ADDENDUM #05

INVITATION TO BID #01

RENOVATION TO THE BRANFORD POLICE HEADQUARTERS 33 LAUREL STREET BRANFORD, CT 06096

October 18th, 2024

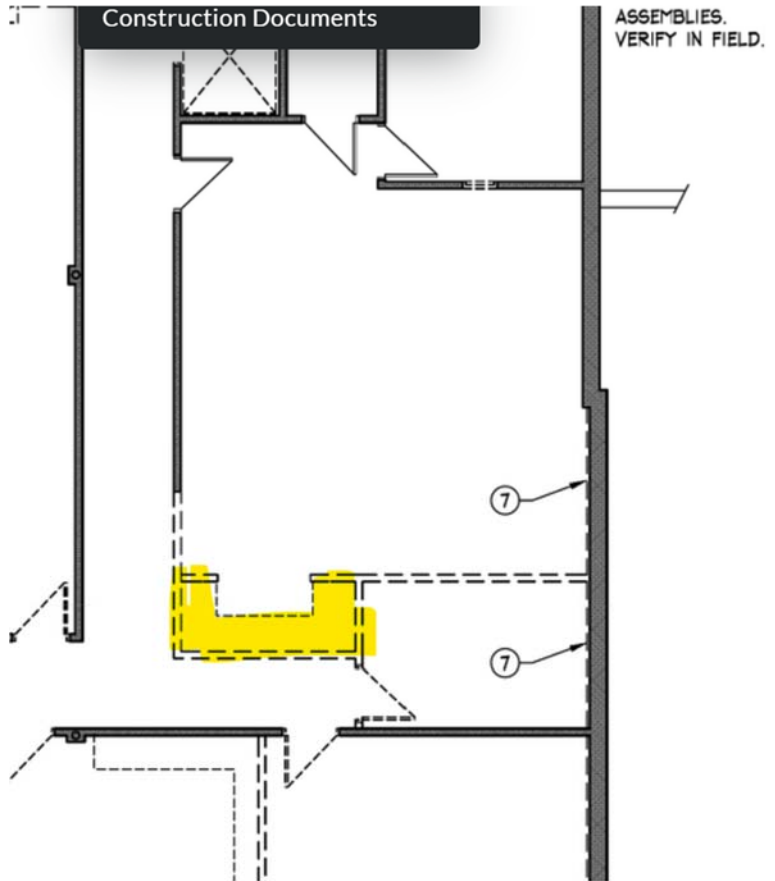
- a. Approximately (12) desks throughout the building and possibly (4) file cabinets or other furniture appurtenances.
- b. Existing countertop in room CONF 126 that spans wall to wall on the east side of this room. See image below from demo plan.

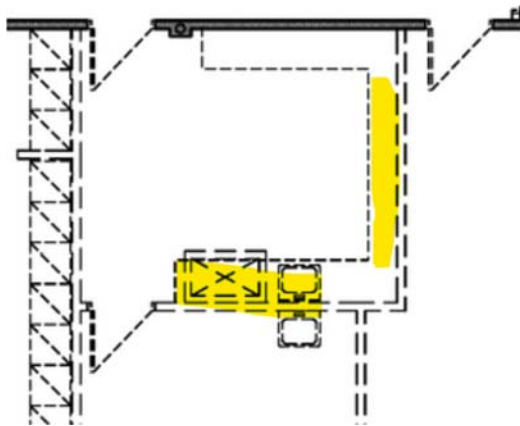
c. Existing shelving in room 003 Roll Call. Refer to demo plan for old U-shaped closet where existing shelving remains See image below from demo plan.
